Docket No. 50-255 April 29, 1976

The Commission has issued the enclosed Amendment No. 21 to Provisional Operating License No. DPR-20 for the Palisades Plant. The amendment consists of changes to the Technical Specifications, and is in response to your requests dated July 9, 1975, and January 30 and April 5, 1976, as supplemented and amended.

PALISADES PLANT

Amendment No. 21
License No. DPR-20

Fig. 3-6
Amendment No. 21

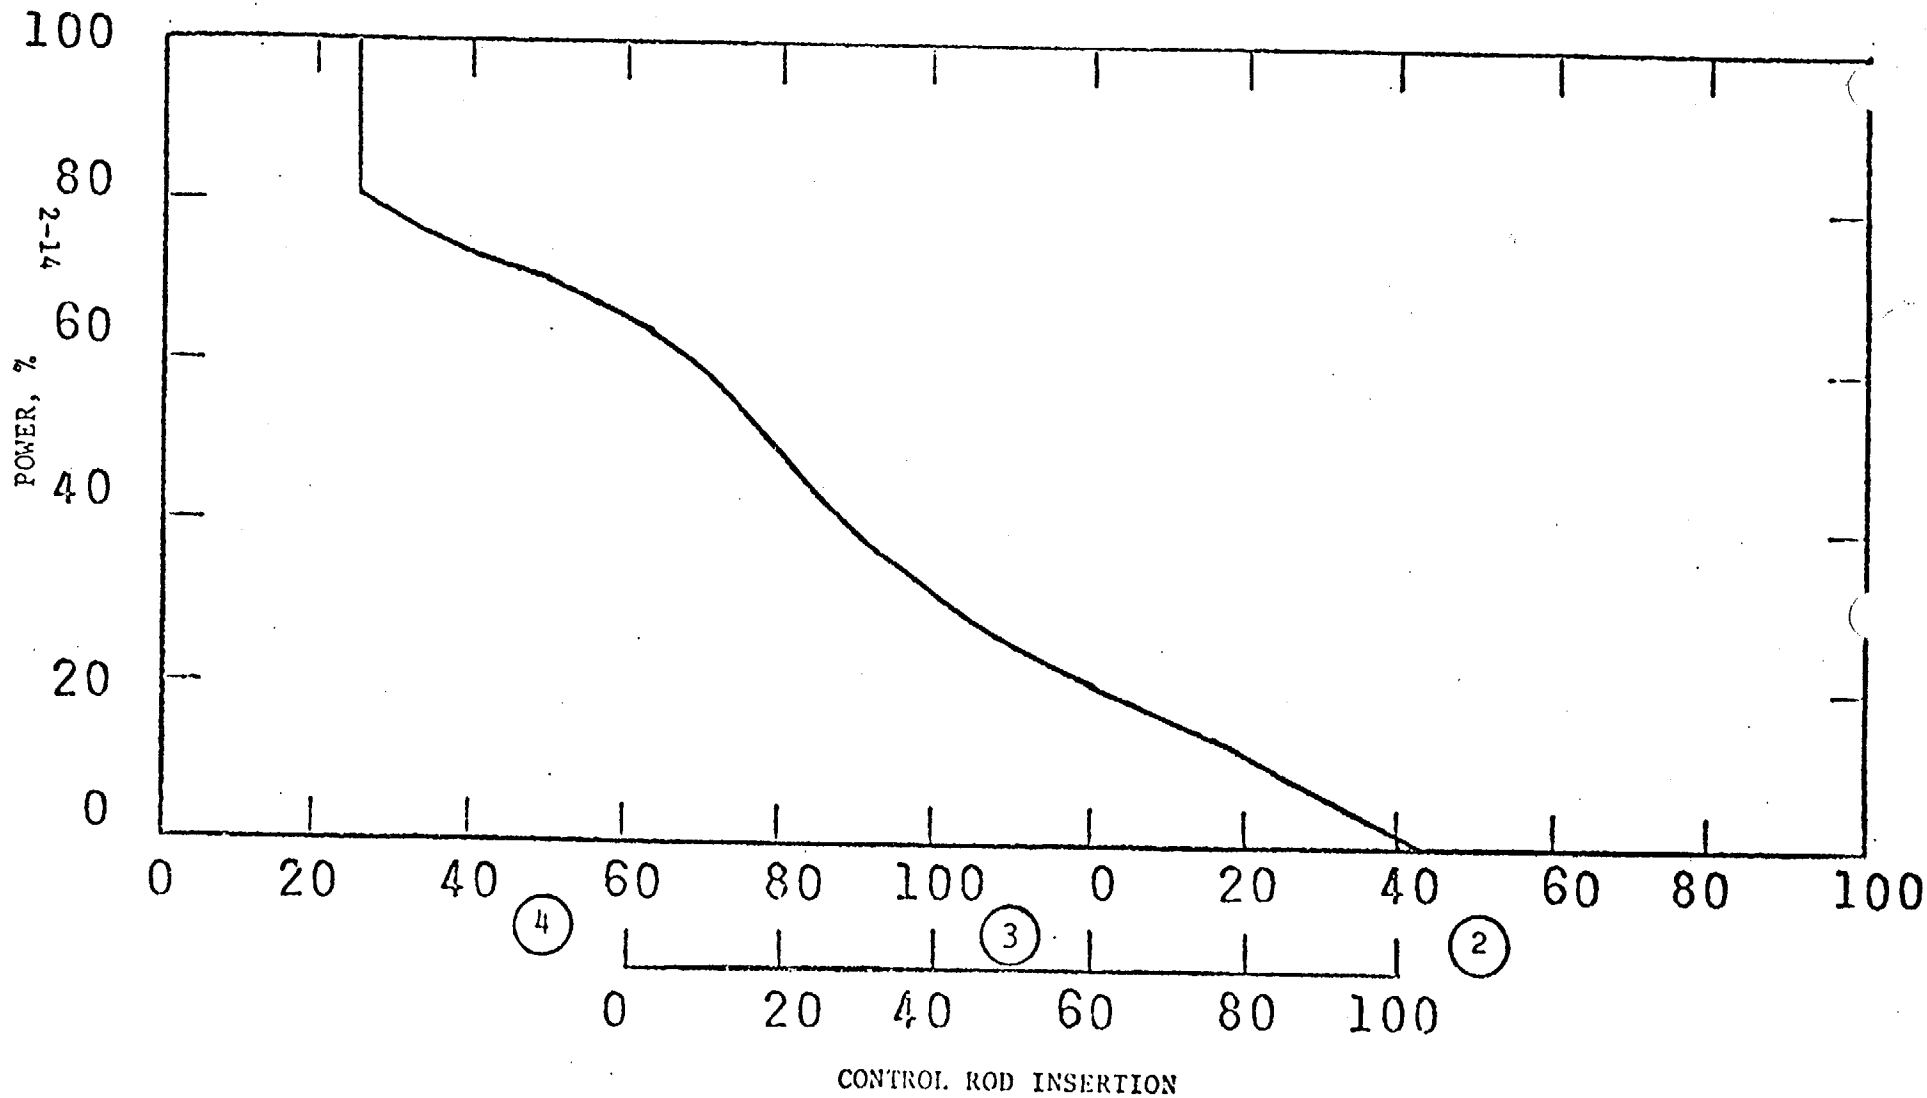
a. To implement the limits on shutdown margin, individual rod worth and hot channel factors, the limits on control rod regulating group insertion shall be established as shown on Figure 3-6. These limits may be revised during fuel cycle life based on physics calculations and physics data obtained during plant start-up and subsequent operation.

d. If the reactor is subcritical, the rod position at which criticality could be achieved if the control rods were withdrawn in normal sequence shall not be lower than the insertion limit for zero power shown on Figure 3-6.

Augmentation Factor Versus Height Monte Carlo Computation for Palisades	Palisades Technical Specifications	Figure 3-7

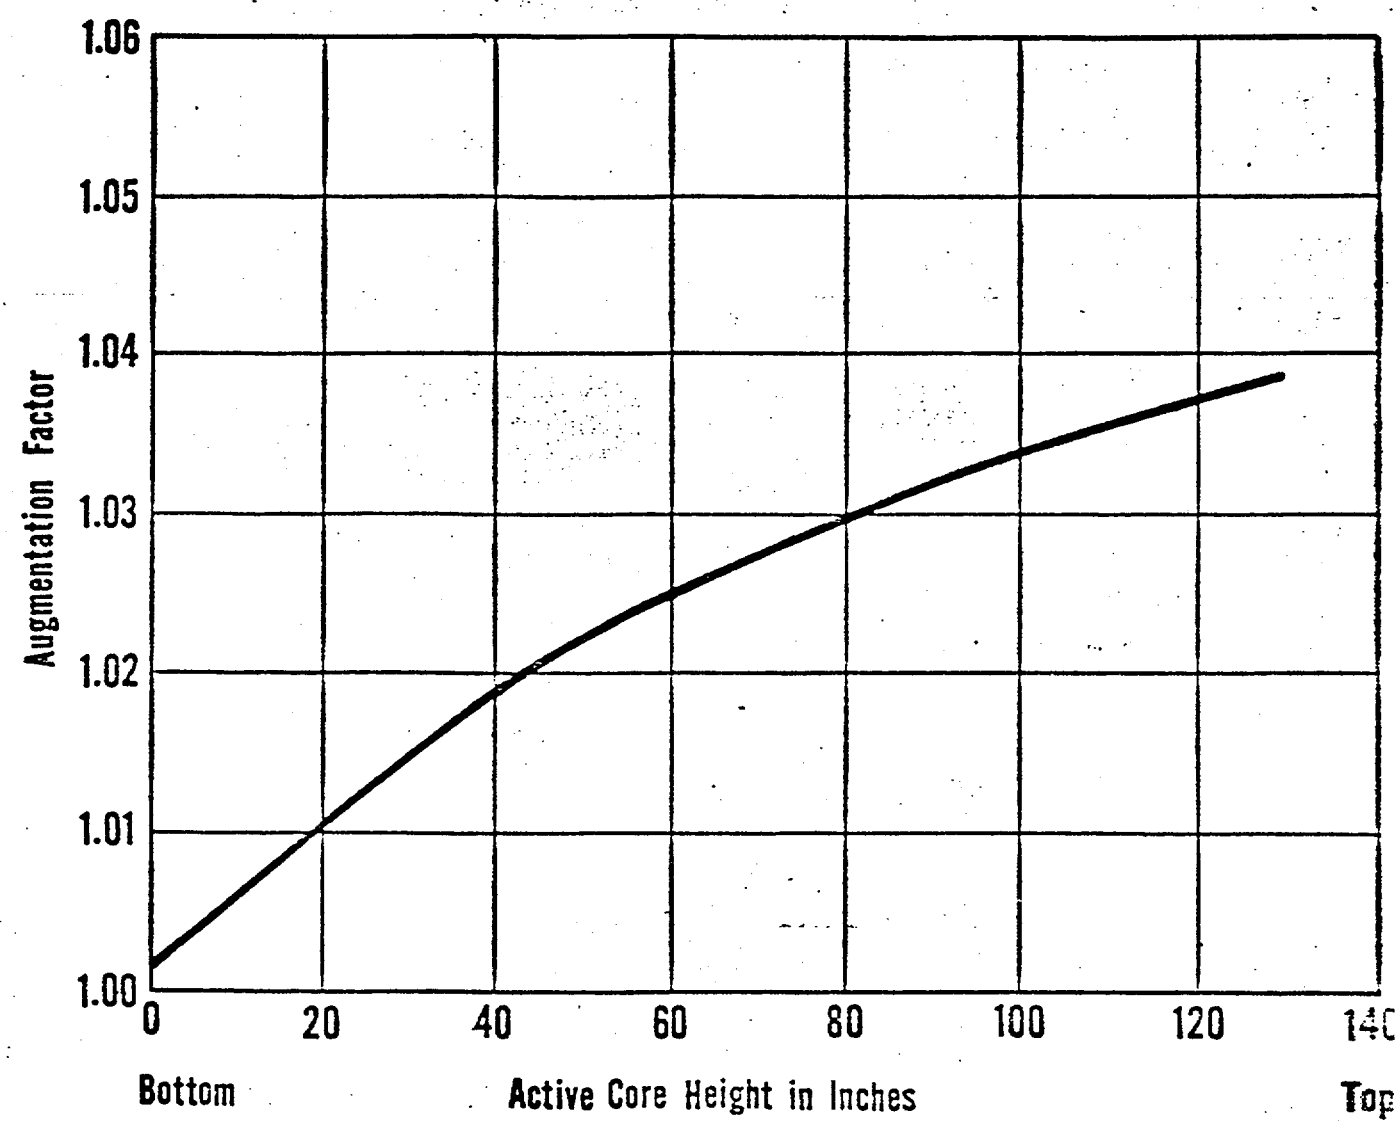
Appropriate factors for measurement-calculation uncertainty, engineering factor and shortening of the fuel pellet stack are specified to insure that linear heat generation rate limits are not exceeded during steady state operation.
